City of Alexandria, Virginia

MEMORANDUM

SUBJECT: DSP #2004-0018 – BEAUREGARD / ARMISTEAD TOWNS

Docket Item #5
DEVELOPMENT SITE PLAN #2004-0018
Beauregard / Armistead Towns

Cross Section Showing Extent of Proposed Grading

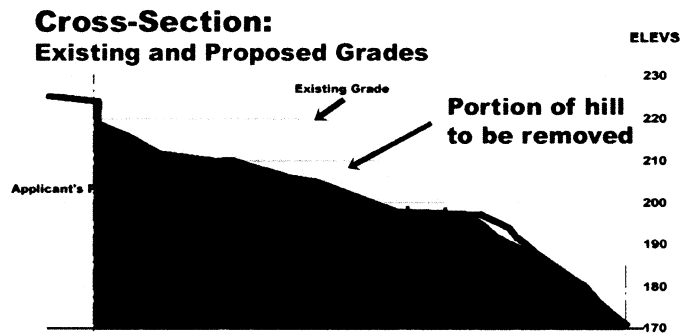
In order to attain compliance, staff is recommending eliminating four units (required in any event to comply with the RA zone’s open and usable space requirement) and shifting the remaining units 19 ft. farther from Beauregard to create a minimum 55 ft. setback and buffer from Beauregard Street. The applicant contends that there are other buildings as close to Beauregard as they are proposing. However, these buildings are generally lower scale buildings and are not elevated by the topography of the

site as proposed by the applicant. In addition, most of the mature vegetation that would otherwise screen that building will be lost during construction. While most of the trees that are on the site are generally not large trees (6-24" caliper trees), collectively the trees create a dense tree canopy for the site and Beauregard. The development as proposed will eliminate much of this wooded area, as it requires the grading of approximately 85% of the property and will result in the loss of at least three-quarters of the trees that have a caliper size of 6" or greater. The degree of change from pre-development to post-development conditions is unnecessary to reasonable development of the site and will be dramatic. The adverse impact of an inadequate buffer will be exacerbated by the topography of this proposed development, as the buildings will be substantially elevated above the street grade.

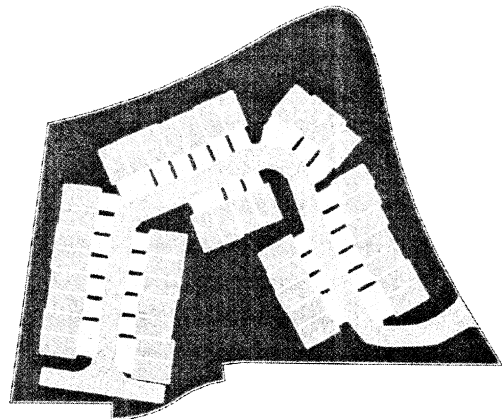
Most of the required setbacks within the Zoning Ordinance include a setback ratio, which requires greater setbacks for taller buildings. This approach is also consistent with the recently completed Ashton Manor development, where the buildings have a setback ratio of greater than 2 to 1 and where the buildings are setback 72 to 88 ft. from the Beauregard roadway. Staff is recommending

that this application provide a setback that is closer to that which has been provided by recent developments in the corridor and will be consistent with the Open Space Plan, which lists Beauregard Street as a tree-lined boulevard which is to be protected and enhanced. This increased buffer, particularly at the intersection of Beauregard and Armistead Streets, will increase the number of trees that can be retained. These changes are the minimum buffer enhancements required to comply with Zoning Ordinance Sections 11-410(C), (F) and (W).

Applicant's Proposed Plan

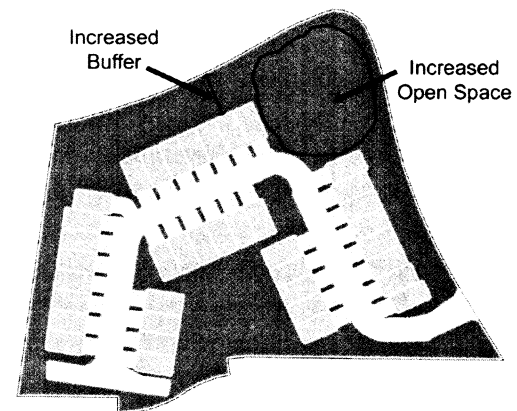
For these reasons, and as stated above, the Director has determined that this application is deficit, as a matter of law, as to open and usable space. Staff will require the elimination of four units as discussed above, not only to provide a larger buffer on Beauregard, but also to provide a useable consolidated open space in a configuration that meets the RA zone requirement. Staff also believes that this configuration will enable the Planning Commission to find that this site plan minimally meets the requirements of Section 11-410(G). These revisions are necessary to provide an adequate amount of open and usable space to the development’s future residents and will also protect and prevent the loss of open space

that contributes to the character of the surrounding area by providing a 21,000 sq. ft. consolidated open area at the intersection of Beauregard and Armistead Streets.

Staff's Proposed Plan
